# Details of Representations

Application ID	24042402
Proposal	14 level residential flat building containing 36 dwellings, all of which are to be offered as affordable housing (social housing)
Location	8 HOCKING PL ADELAIDE SA 5000

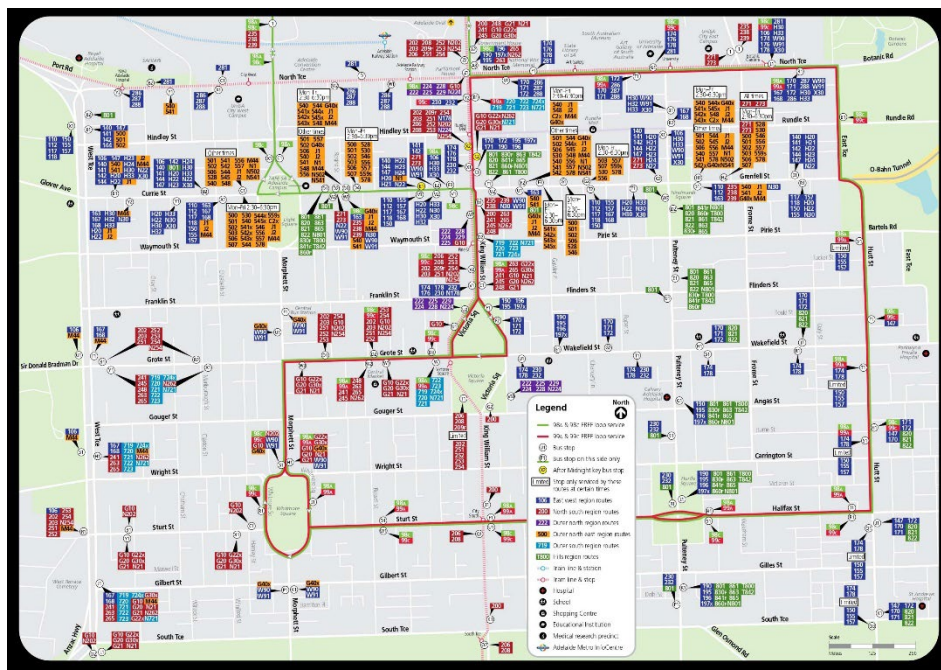
Within Lane World there are a mere 3 (small) on-street car parks.

The groin of the Square at the Hocking Place junction reduces carparking in front of the subject to one space.

Typical Floor Plan  
Level 11 - 13

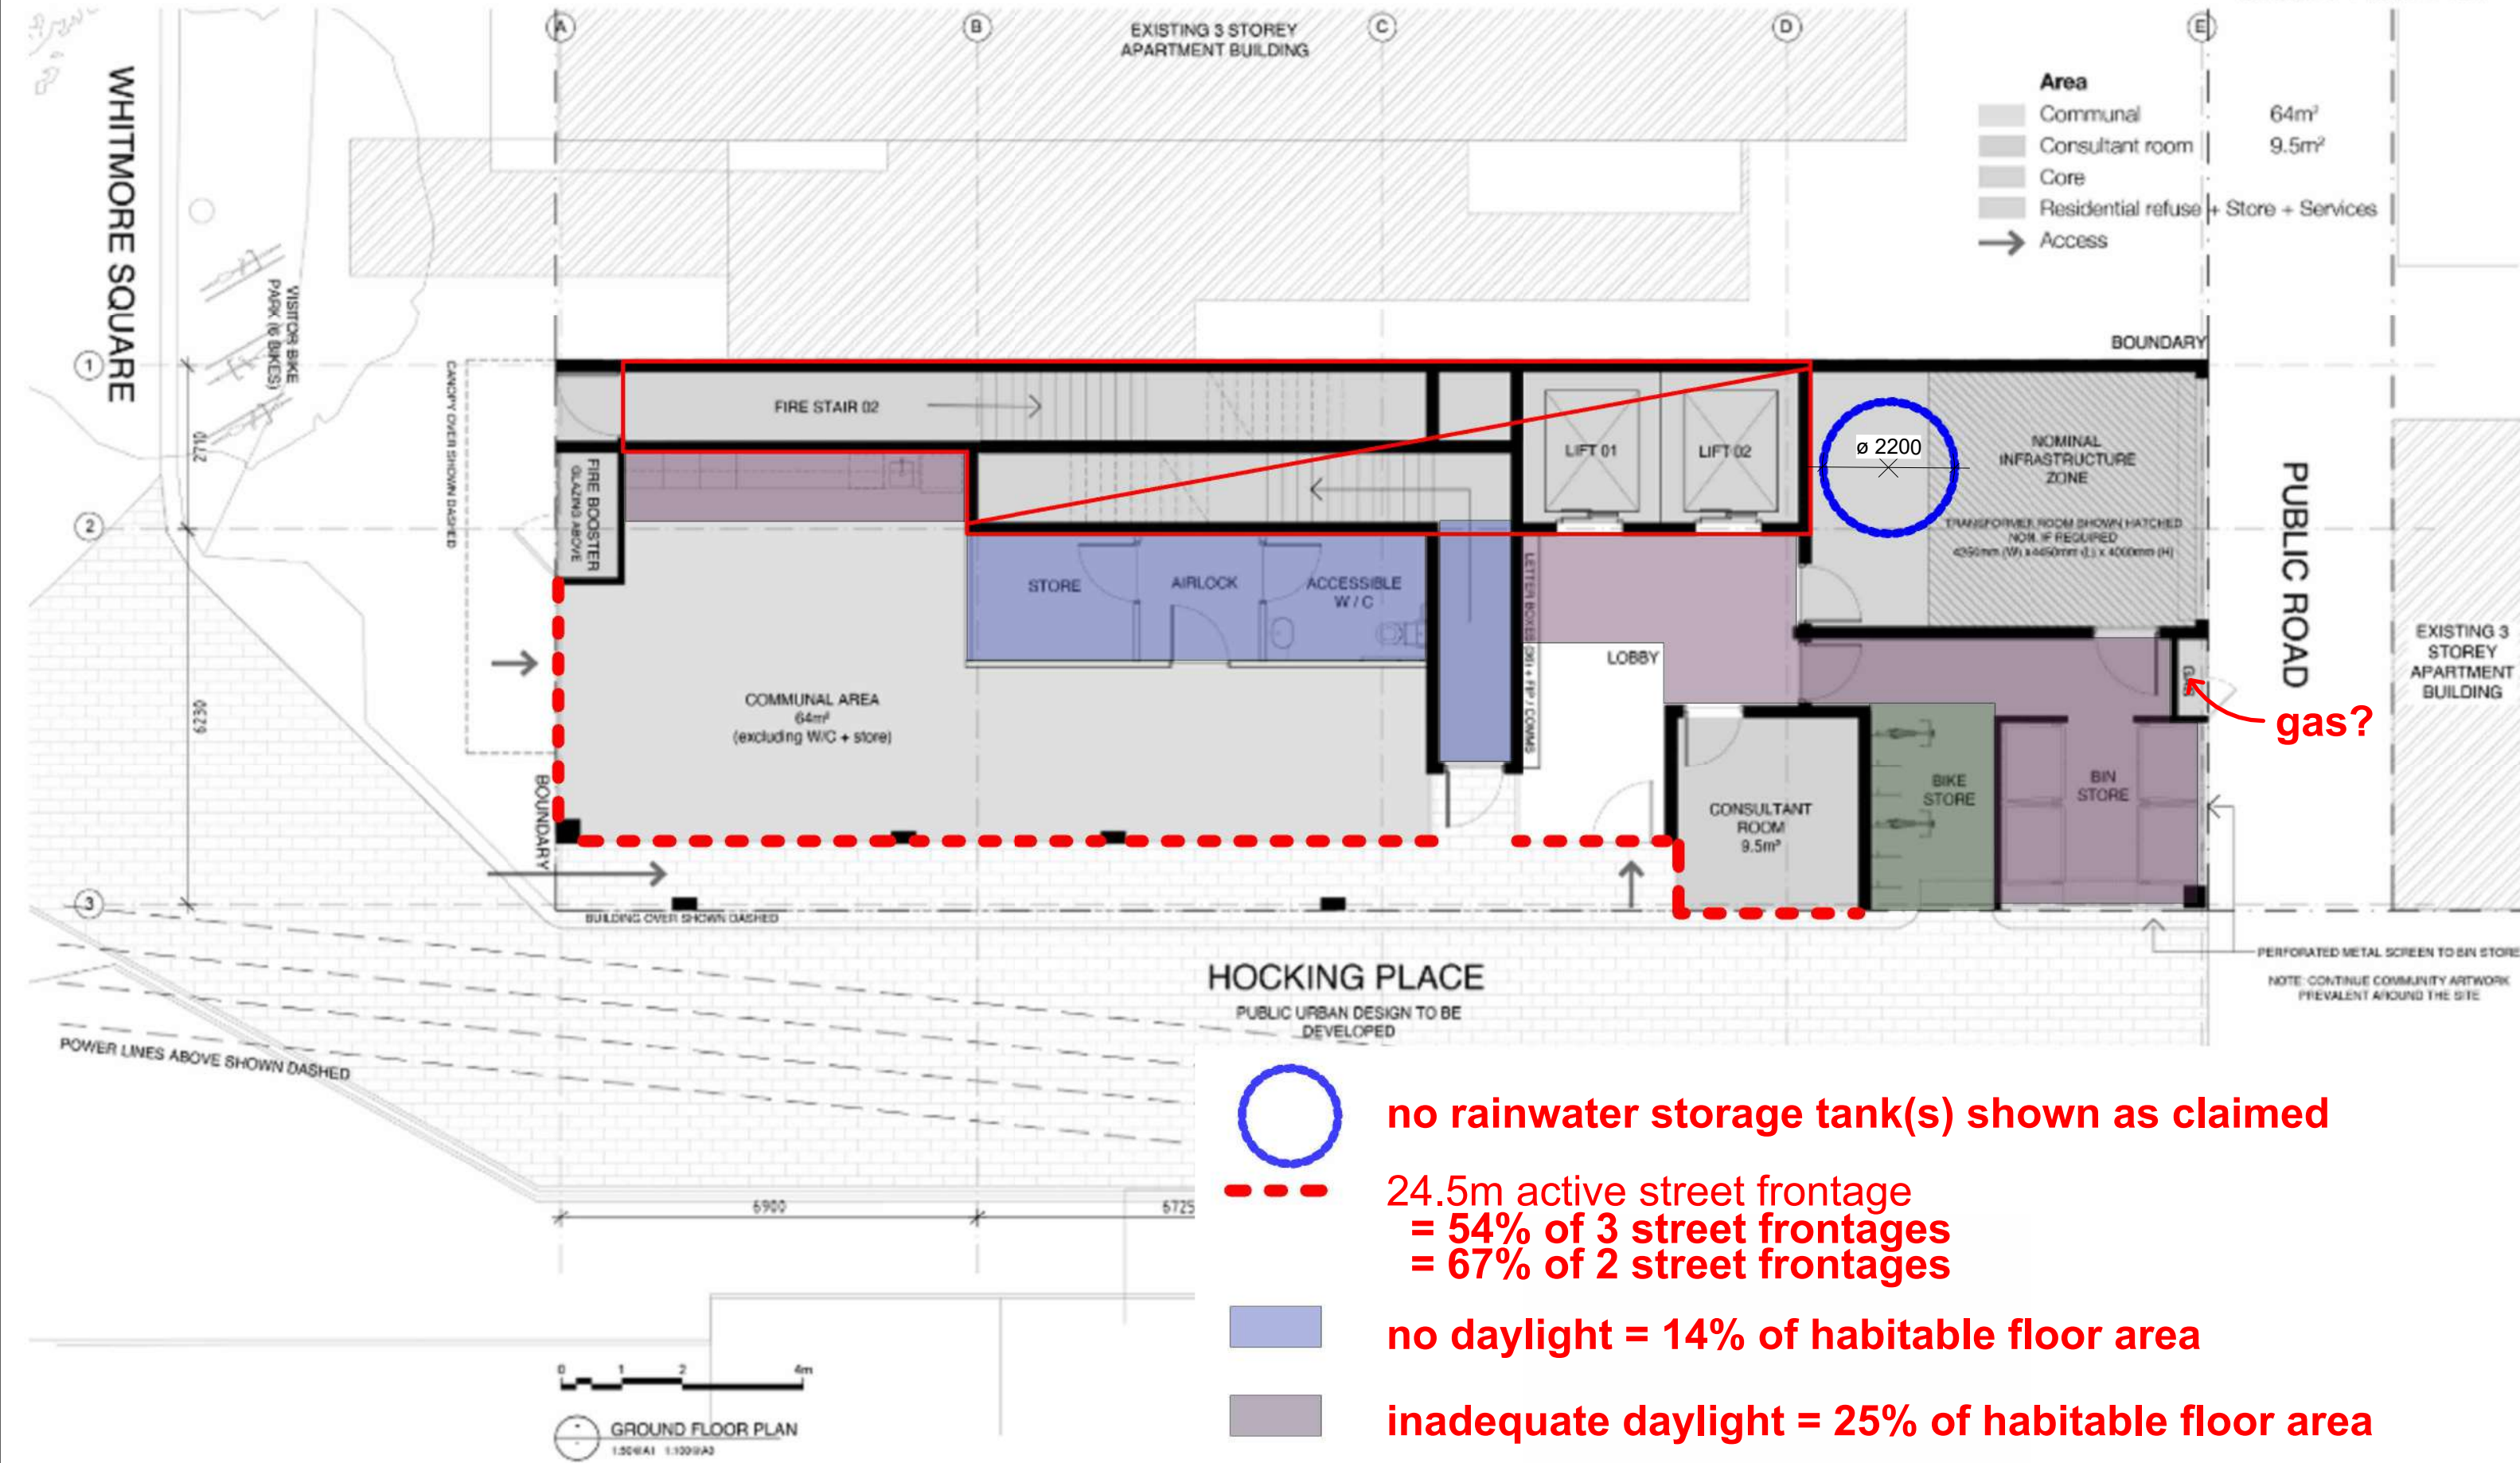
- at the upper three levels, apartments provide two bedrooms (two rather than three dwellings per floor) with a floor area of 82 m<sup>2</sup> and an 11 m<sup>2</sup> balcony – once again, the shared corridor is not provided with natural ventilation or light

The general 3.2m floor/ floor height is considered tight with due consideration for structure and services, including the passage of water and stormwater pipes, and able to deliver a 2.4m ceiling height. Although dwelling unit areas are only small, the question is how ignoble is that – would that cut it for your or my apartment? Are ceiling fans proposed?

Typical Floor Plan  
Level 04

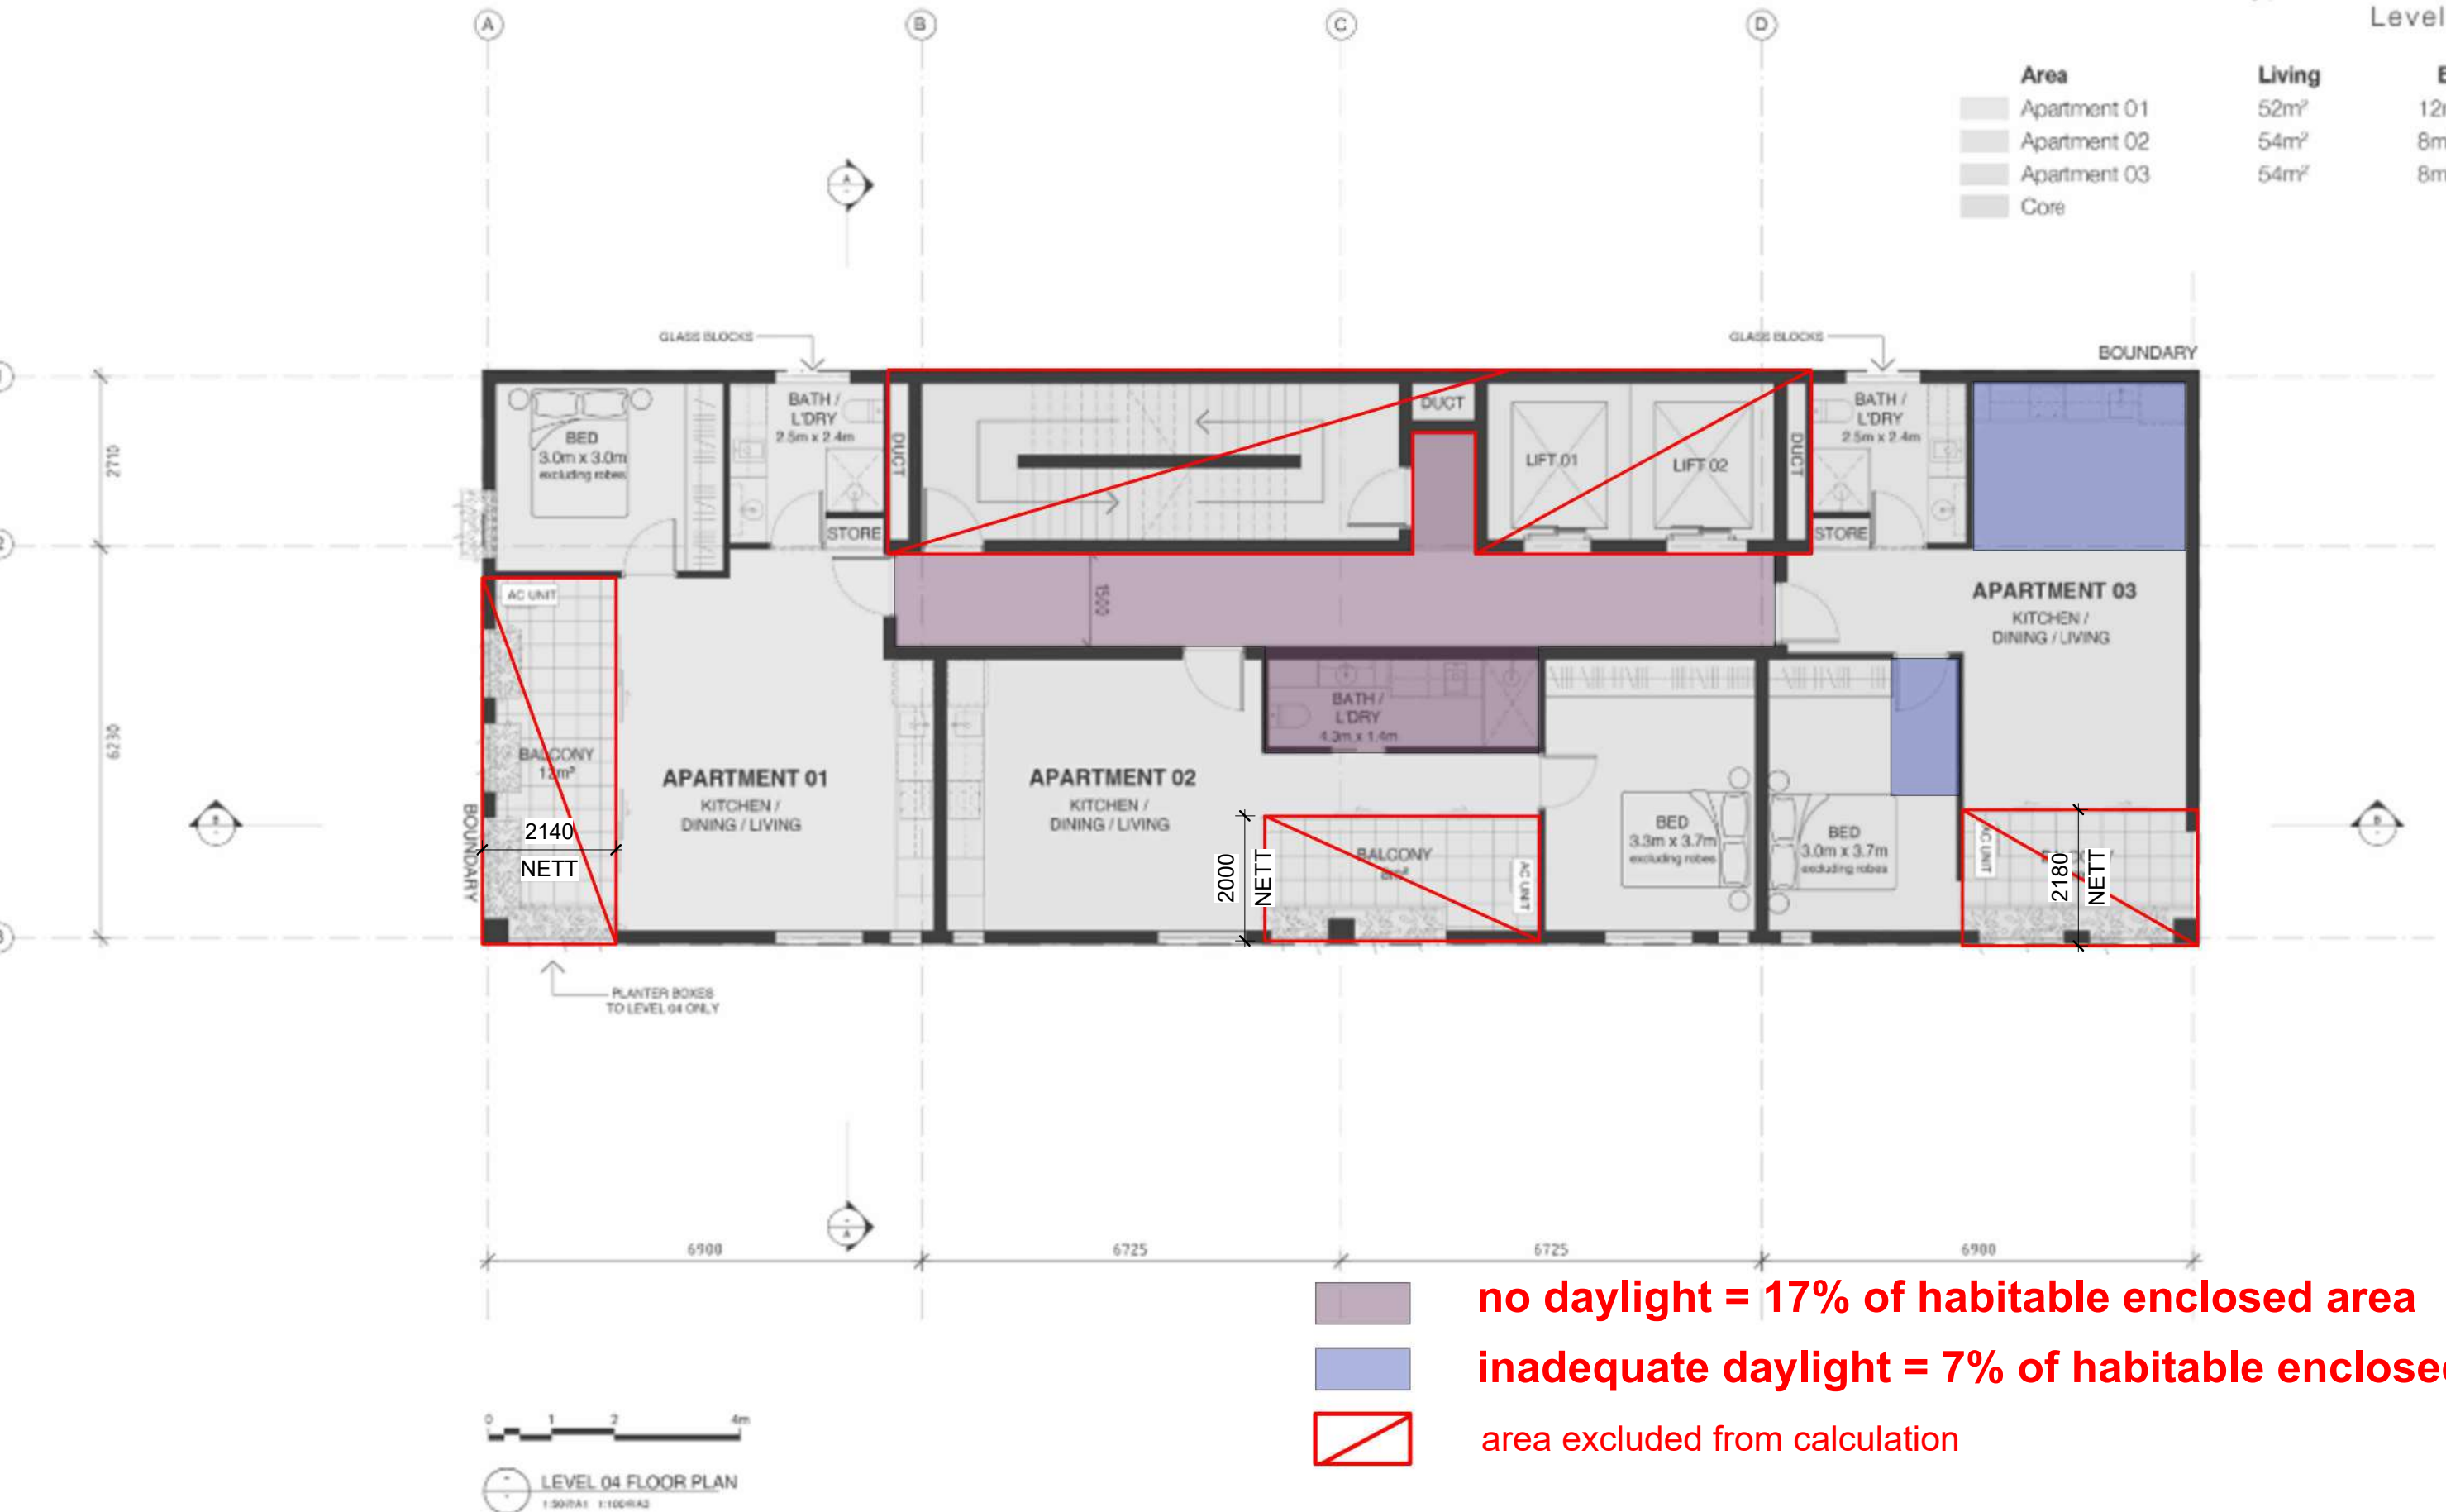
- apartments on Levels 1 to 10 are to be for a single bedroom and open plan kitchen, living and dining area totalling 54 m<sup>2</sup> each with a balcony of either 8 m<sup>2</sup> or 12 m<sup>2</sup> – the shared corridor is not provided with natural ventilation or light;
